## DESCRIPTIVE REPORT

Registry No. H-10974

General Locality Northern Shelikof Strait

Sublocality Cape Ugyak to Devils Cove and  
Vicinity of Kukak Point

Figure 3: H10974 Survey Junctions

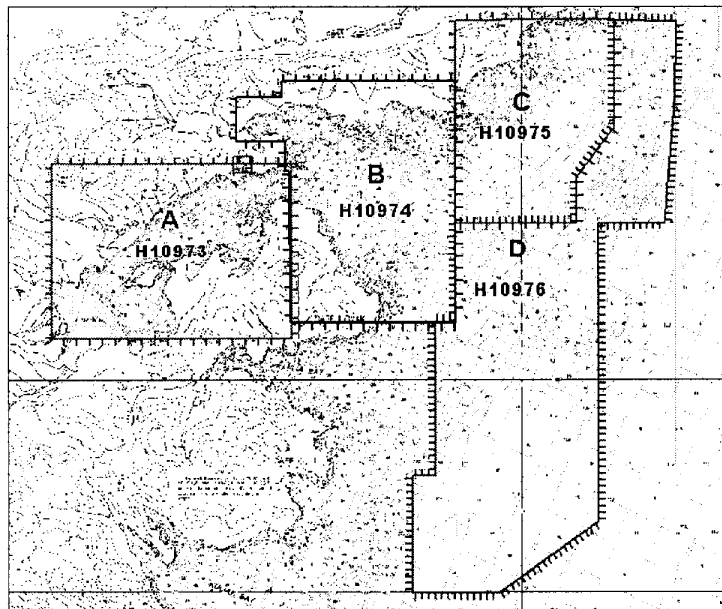
At the time of this report, processing of H10973 was not complete. Comparisons with H10973 will be discussed in the Descriptive Report for H10973. *Comparison on this survey was done during office processing.*

Survey H10975 junctions well with this survey. Depths generally agree within one fathom or less. *Concur.*

Survey H10976 junctions well with this survey. Depths generally agree within one fathom or less. *Concur.*

Figure 4: Chart comparison in vicinity of 20-fathom curve

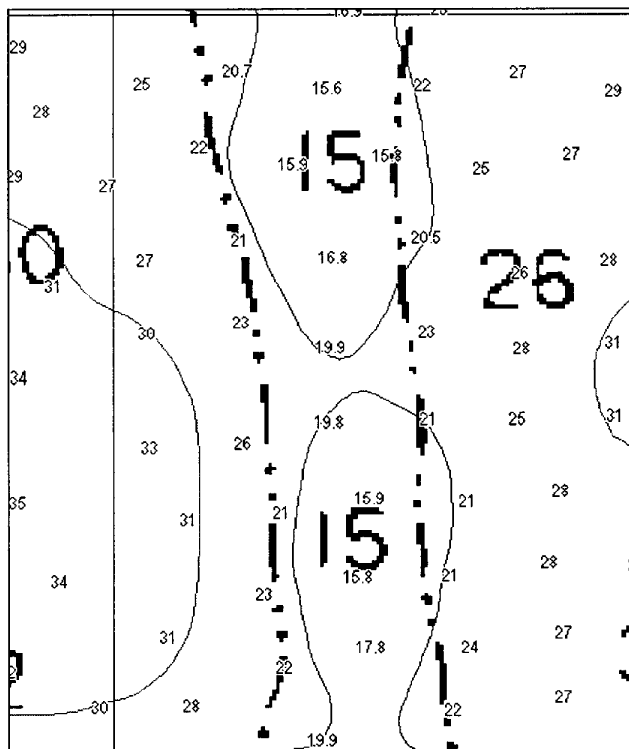
Between charted 15-fathom soundings at 58°19'21.24"N, 154°07'18.91"W (434,283.5E, 6,465,171.0N), survey H10974 obtained soundings of up to 22 fathoms. However, survey soundings agreed with charted soundings at the positions of the charted 15-fathom soundings. Soundings from H10974 also agreed within one fathom with those of prior survey H-7822. The Hydrographer believes that the 20-fathom curve has been generalized on charts 16603 and 16576, and therefore the deeper soundings are not depicted. The area was covered with 100% SWMB. The Hydrographer recommends depicting the deeper depths to define the break in the ridge, as is practicable at chart scale. This difference is depicted in Figure 4. *Do not concur. Depiction of break in the ridge for insignificantly deeper depth of 21 & 20.5 fathoms is not necessary considering the scale of the chart.*
